In the matter of an application by **Dunedin City Council** and the **Department of Conservation** for consent to construct and operate a carpark at Tunnel Beach, Dunedin

Statement of evidence of Brendon Shanks

20 April 2022

Figure 1: 1.5m high noise barrier

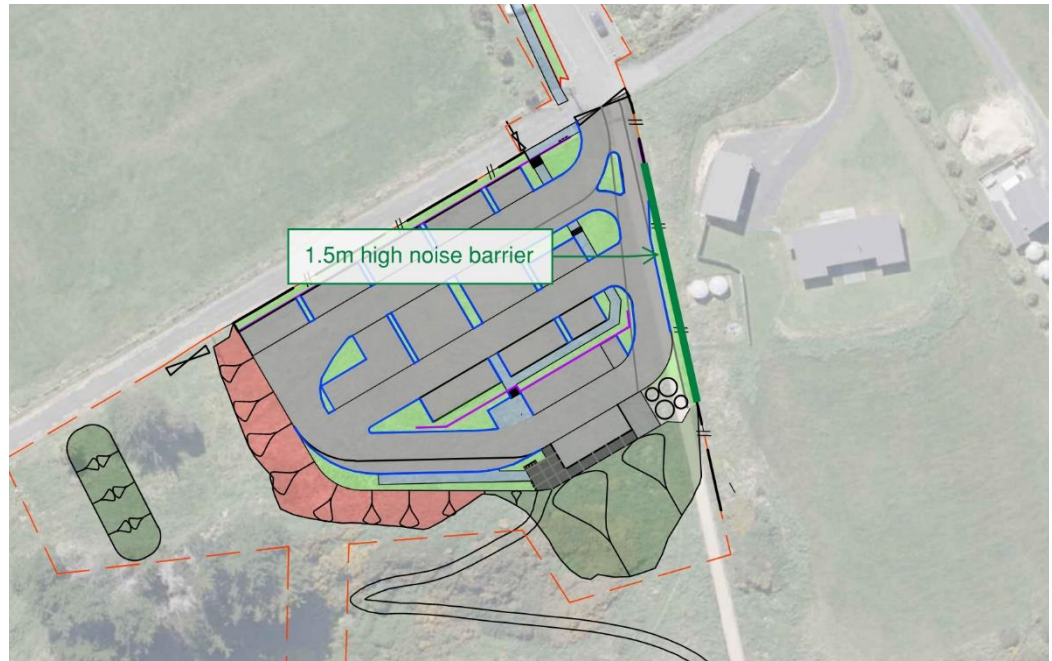
- 20 The section 42A report agrees with the conclusions of our assessment but recommends including a noise barrier between the carpark and 31 Tunnel Beach Road to reduce noise at this property. I agree with this recommendation and a 1.5m high noise barrier has been included along a section of the boundary with 31 Tunnel Beach Road. The extent of the barrier is shown in the figure below.

- 21 The barrier will be constructed with no gaps (a timber fence with overlapping palings) and will block line of sight between the carpark and the assessment positions at 31 Tunnel Beach Road. This has been included in the proposed design and my predicted noise levels have been updated to include the shielding effects of the barrier.
